Fire Risk Assessment 548 Forest Road, Walthamstow Version 5

13 September 2023

Review Date: 13 September 2024 Score: Tolerable Risk Assessor: Andy Harris

A pram, and other combustibles in the gas meter cupboard, ground floor.

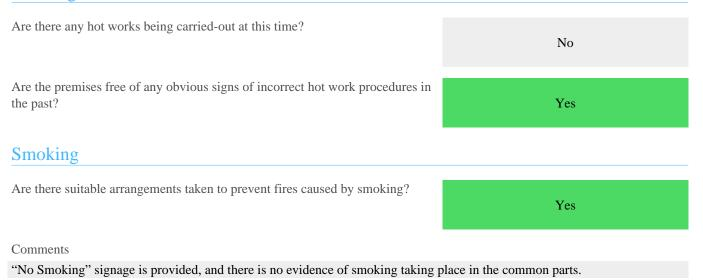
Source Version	2	
Category	Fire Prevention	
Sub Category	Housekeeping	
Action Required	The storage of combustible items in riser cupboards should be prohibited.	
	A pram and other combustibles were found within the gas meter cupboard, ground floor.	
	VERSION 4: It was noted that this remedial work, recommended in previous FRAs, has not been completed,	
	13/09/2023 This task remains outstanding	
Priority	Medium	
Status	Identified	
Owner	Neighbourhood Services	
Due Date	12 November 2020
